MRP Materials Reliability Program

MRP 2016-039

SUBJECT: Transmittal of *Materials Reliability Program: Topical Report for Primary Water Stress Corrosion Cracking Mitigation by Surface Stress Improvement (MRP-335 Revision 3-A)*, EPRI, Palo Alto, CA: 2016. 3002009241.

This letter transmits the subject EPRI Topical Report, MRP-335 Revision 3-A. This non-proprietary report is a revision to MRP-335 Revision 3 [1] that incorporates the four Conditions specified in the corresponding U.S. Nuclear Regulatory Commission Safety Evaluation [2]. All changes to the report from Revision 3 to Revision 3-A, except corrections to any typographic errors, are marked with margin bars and summarized in the Record of Revisions table of the report. In accordance with a NRC request, the SE cover letter and final SE are reproduced at the beginning of the report and the report number includes an “-A” indicating the version of the report accepted by the NRC staff.

Figure 4-1
Required Peening Coverage Zone for RPVHPNs with Incidence Angle, θ , ≤ 30 deg (Except Head Vent Nozzles) and for All RPVHPNs with Outer Diameter ≥ 4.5 in. (115 mm)

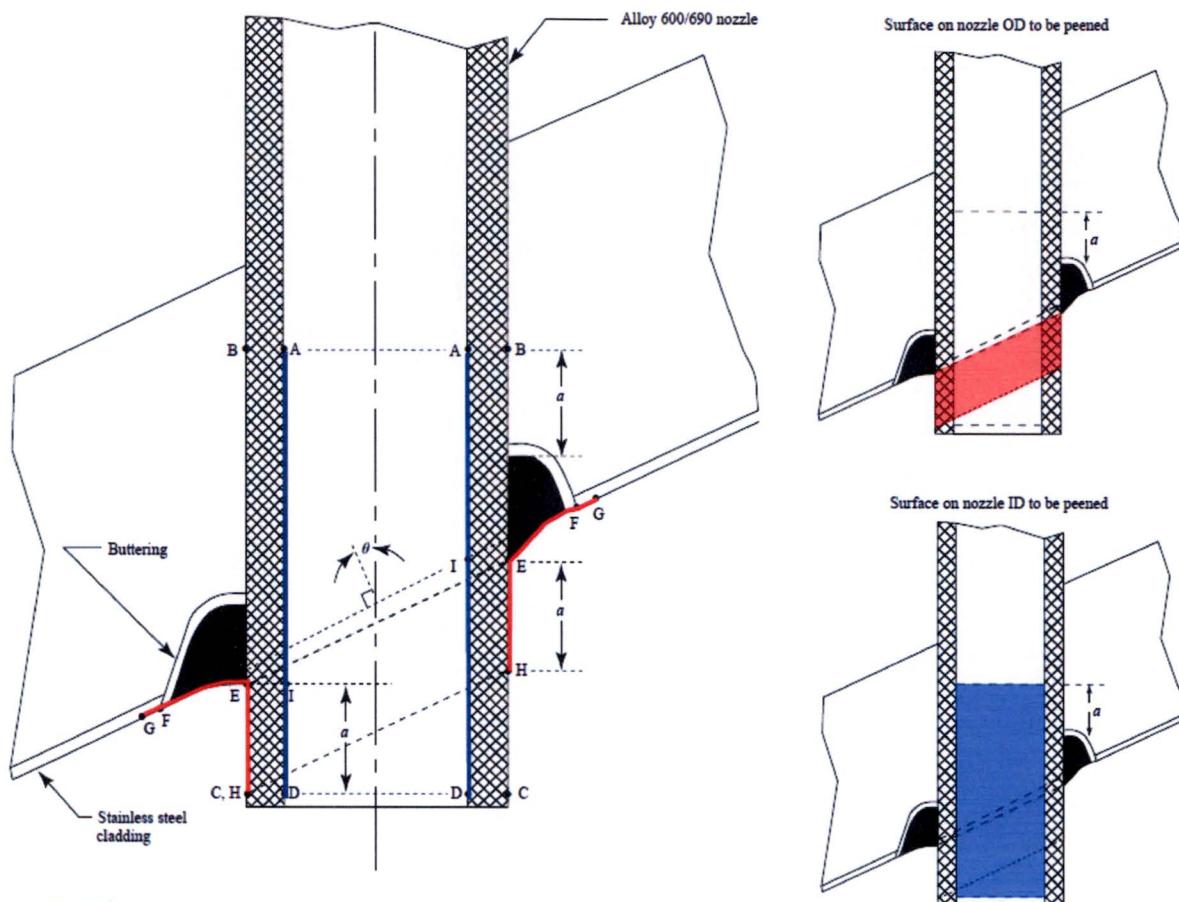
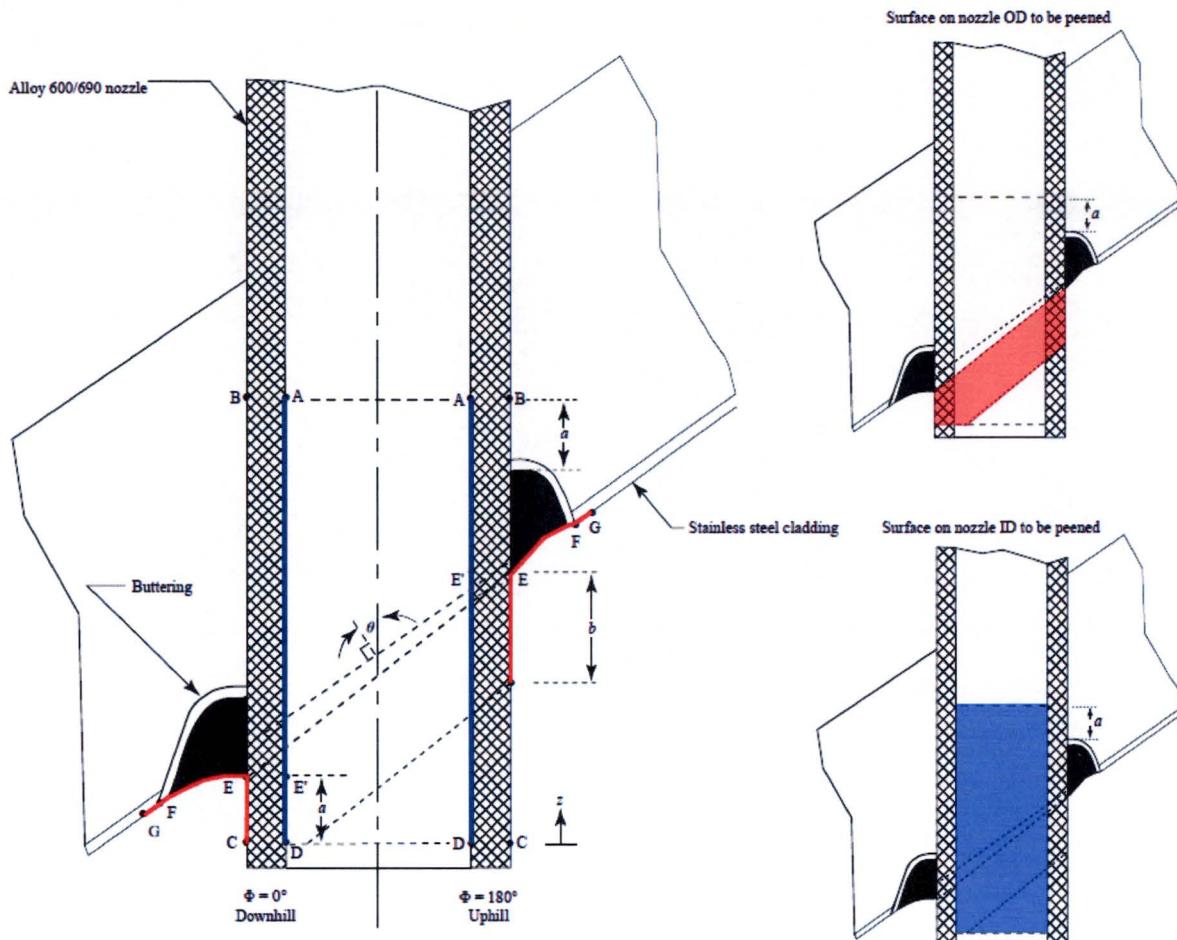
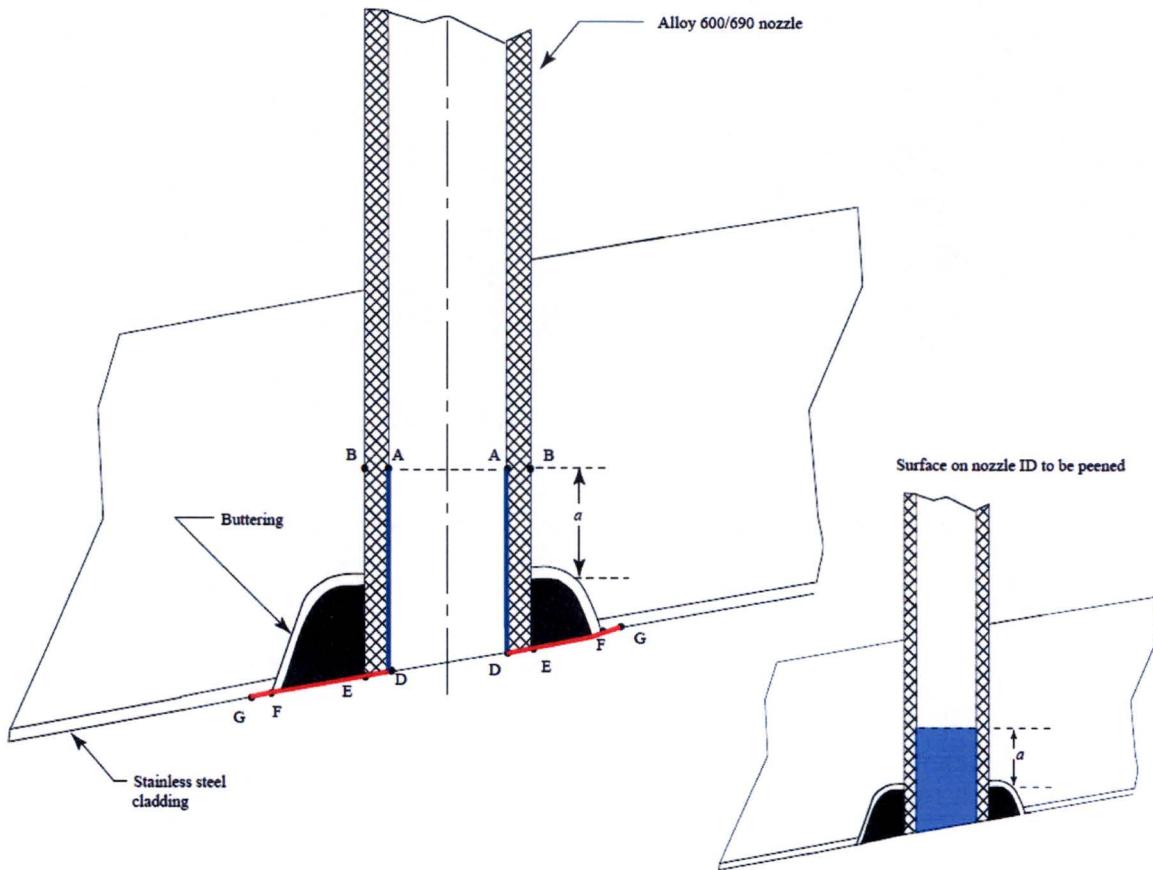
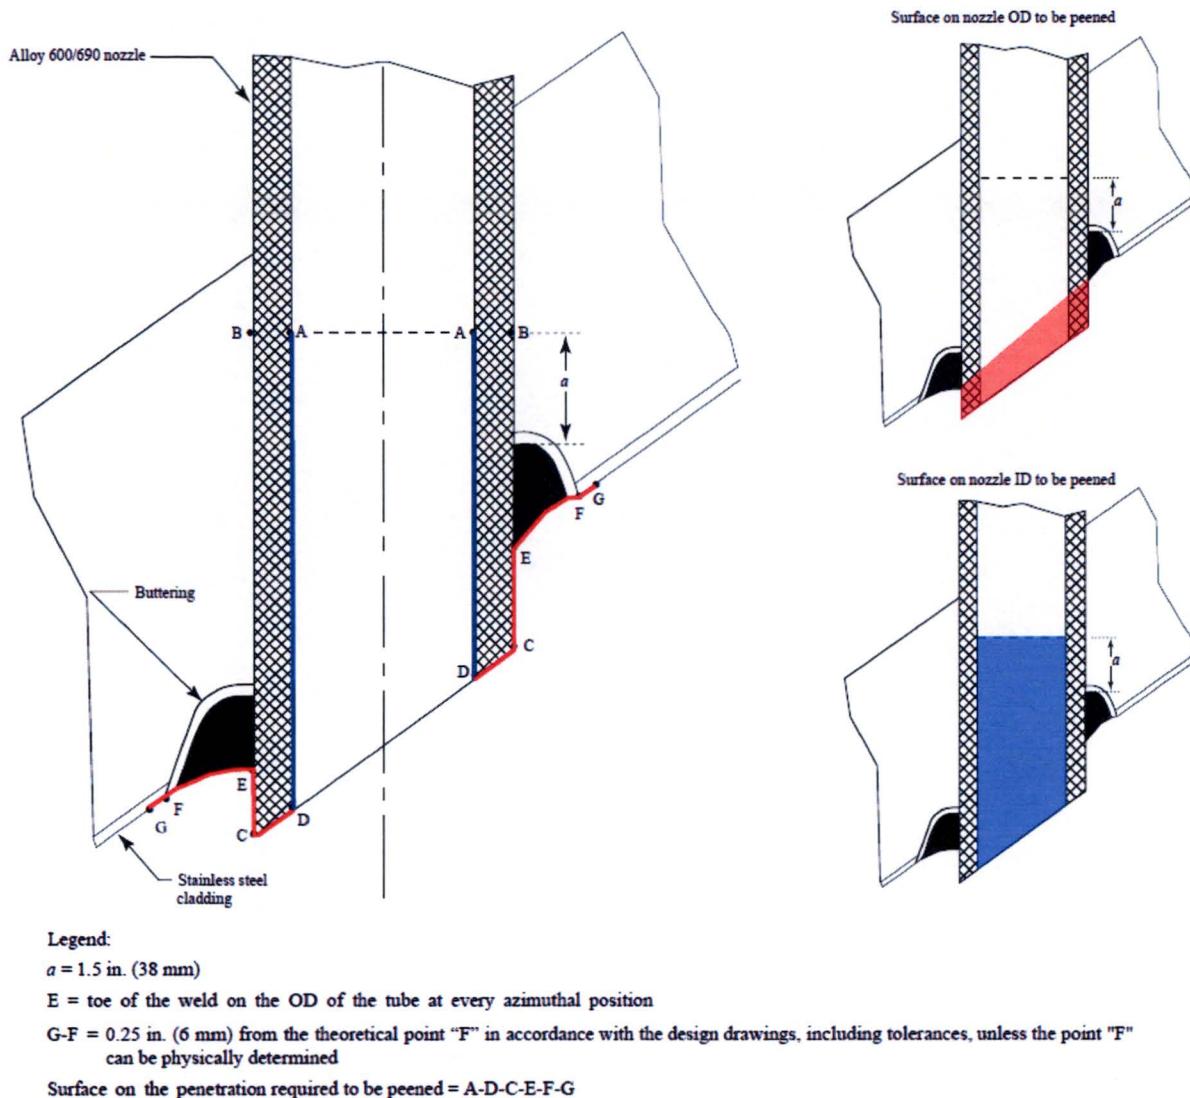
The MRP stated that the required peening coverage is the full wetted surfaces of the attachment weld, butter, and nozzle base material in the region defined in Figure 4-1 through Figure 4-4 of MRP-335R3. The MRP specified the peening coverage to ensure that areas susceptible to PWSCC initiation are mitigated. Section 4.3.8.1 of MRP-335R3 requires that the boundaries of the area required to be effectively peened in Figure 4-1 through Figure 4-4 be extended a suitable distance for the specific peening method to provide high assurance that the areas susceptible to PWSCC receive the required peening effect.

The NRC staff finds that the peening coverage is adequate because Figure 4-1 through Figure 4-4 of MRP-335R3 show the susceptible surface areas of the RPVHPN and J-groove weld that will be peened.

The required coverage is the full wetted surfaces of the attachment weld, butter, and nozzle base material in the region defined in Figure 4-1 through Figure 4-4. As discussed in Section 2.3.3, these coverage figures were specified to ensure that areas susceptible to PWSCC initiation are mitigated. Section 4.3.8.1 requires that the boundaries of the area required to be effectively peened in Figure 4-1 through Figure 4-4 be extended a suitable distance for the specific peening method to provide high assurance that the areas susceptible to PWSCC receive the required peening effect.

Figure 5-35

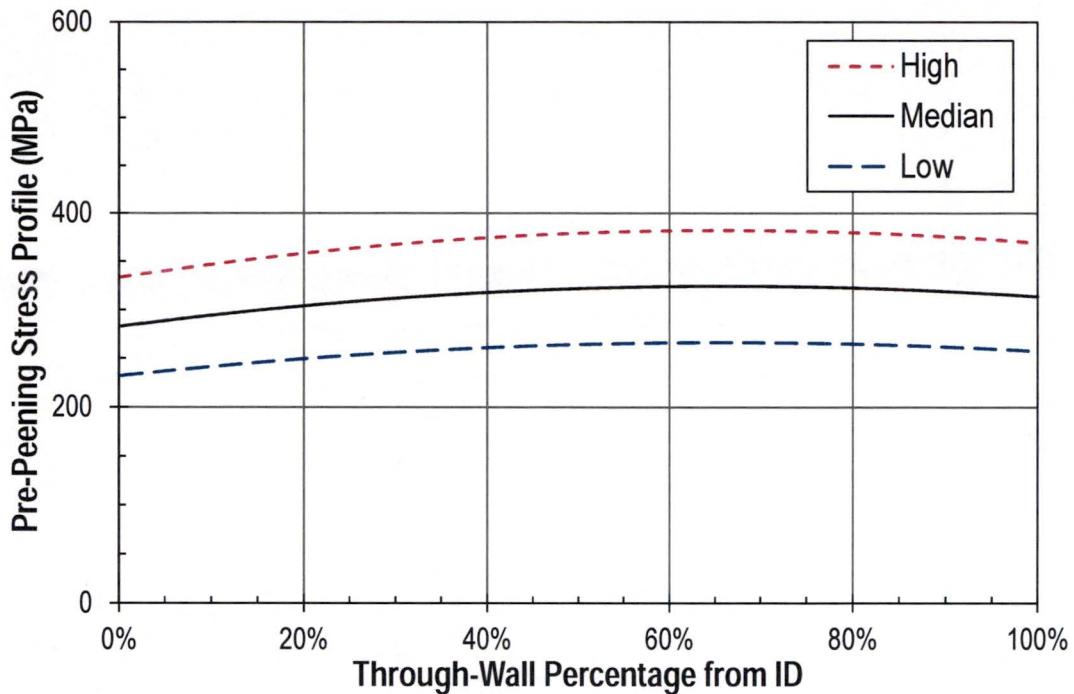
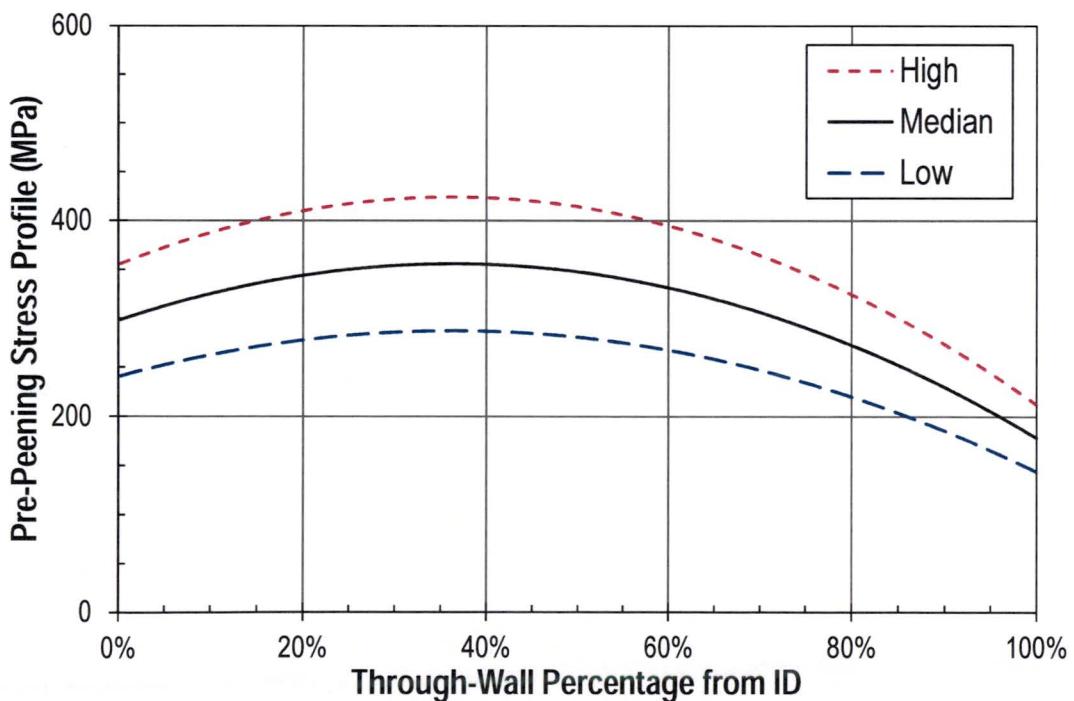
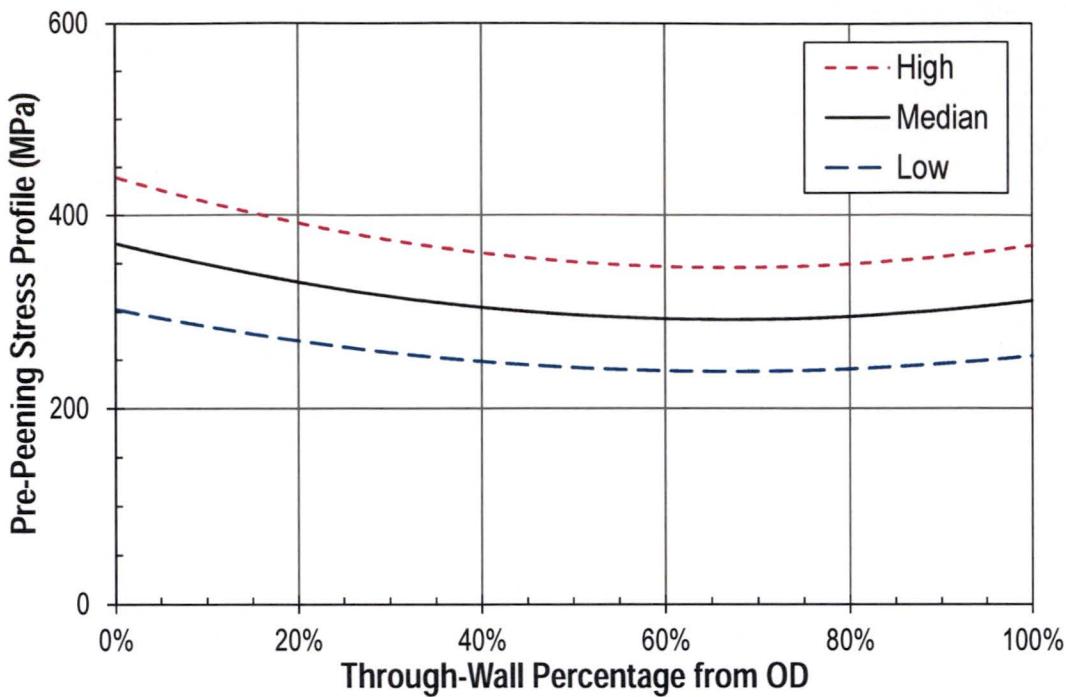
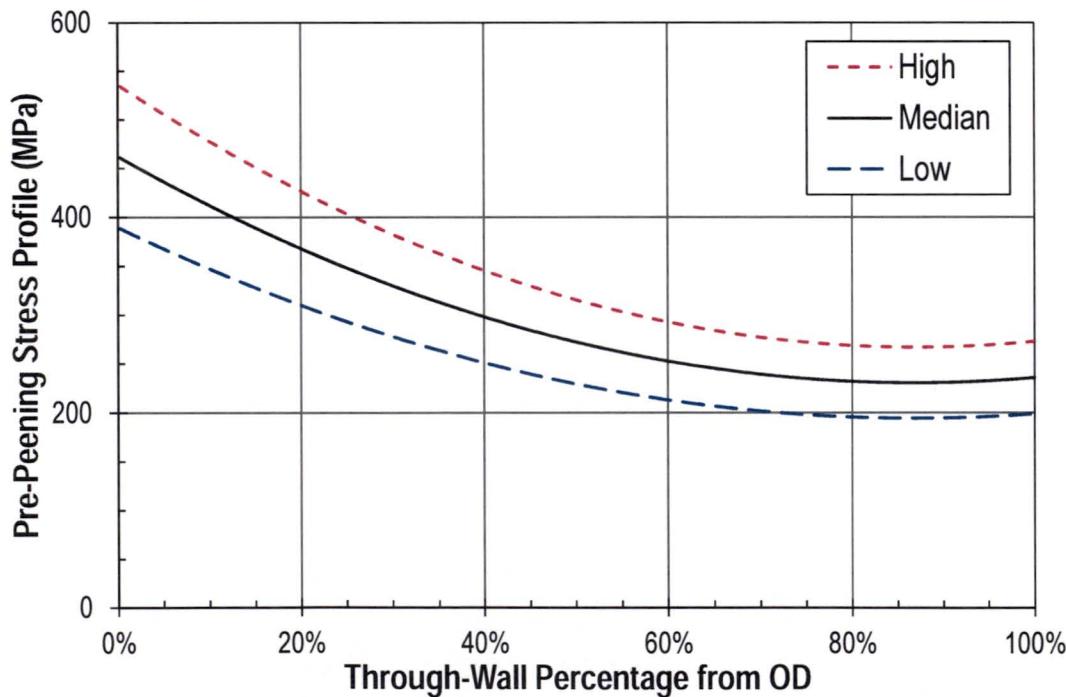
Of particular note was the NRC staff's comparison of the residual stress profiles in Figure 5-35 through Figure 5-38 of MRP-335R3 with the residual stress profiles of MRP-95, Revision 1. Appendix A of MRP-95R1 provides the residual stress profiles for four limiting plants. The stress profiles in Figure 5-35 through Figure 5-38 present the mean and plus one standard deviation and minus one standard deviation stress profiles calculated using a finite element analysis. The variability of the stress profiles from inside to outside diameter of the RPVHPN are significantly more varied in MRP-95R1 than those used in Figure 5-35 through Figure 5-38 in part because MRP-95R1 reported bounding profiles while Figure 5-35 through Figure 5-38 used a single standard deviation level for the limiting analyses. As such, the NRC staff finds the weld residual stress profiles for the deterministic calculations in MRP-335R3 were neither high enough nor low enough to bound the stress profiles of the peened RPVHPN.
